BURLINGTON DEVELOPMENT REVIEW BOARD Tuesday May 19 2015 PUBLIC HEARING NOTICE

BURLINGTON DEVELOPMENT REVIEW BOARD Tuesday, May 19, 5:00 p.m. Contois Auditorium, City Hall, 149 Church Street, Burlington, VT AGENDA

To: Development Review Board
From: Mary O'Neil, AICP, Senior Planner
Date: May 19, 2015
RE: 54 Muirfield Drive, ZP15-1039CA/HO

JOB MEMO: 451 & 465 Appletree Point Road
RE: DRB & DAB Application Submittal
DATE: March 26, 2015
TO: Scott Gustin, Burlington Planning and Zoning
FROM: Brad Rabinowitz

DATE REVISION

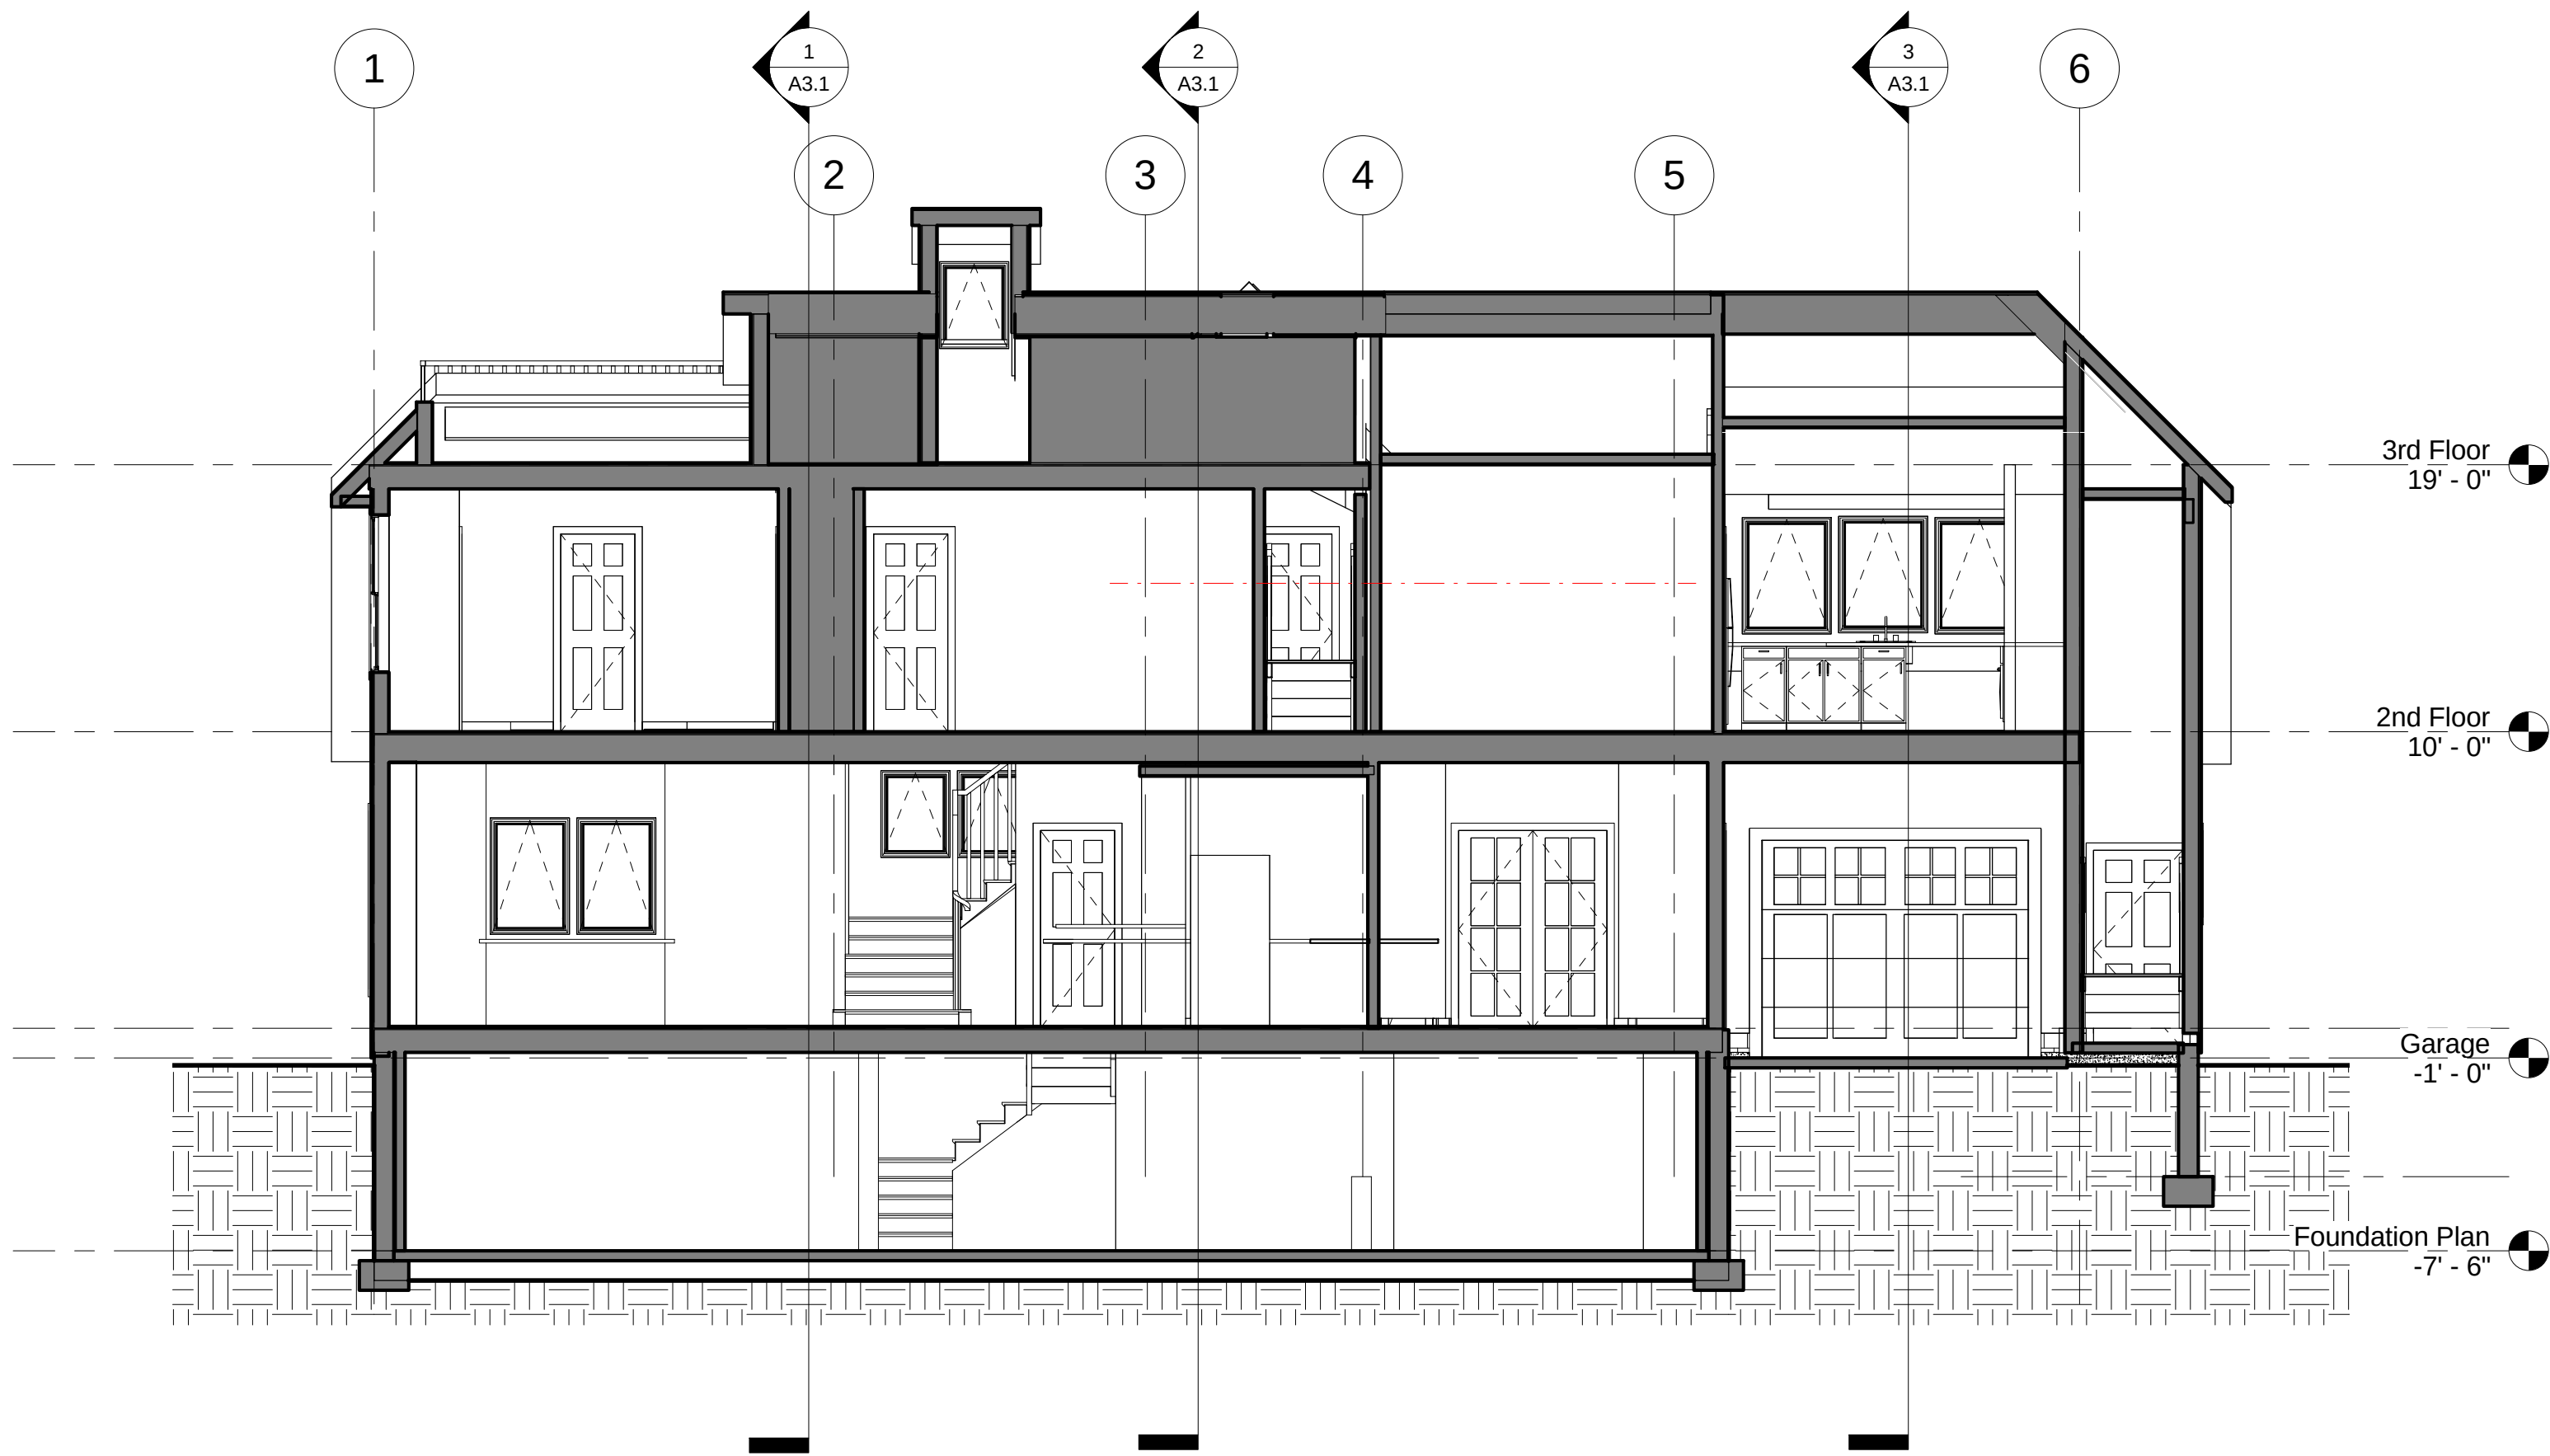
The multiple roof planes and dormers make a clear height measurement to the midpoint of the roof rise elusive. It appears to be about 20.' The very peak of the structure is 33', below the 35' height limit. **(Affirmative finding)**
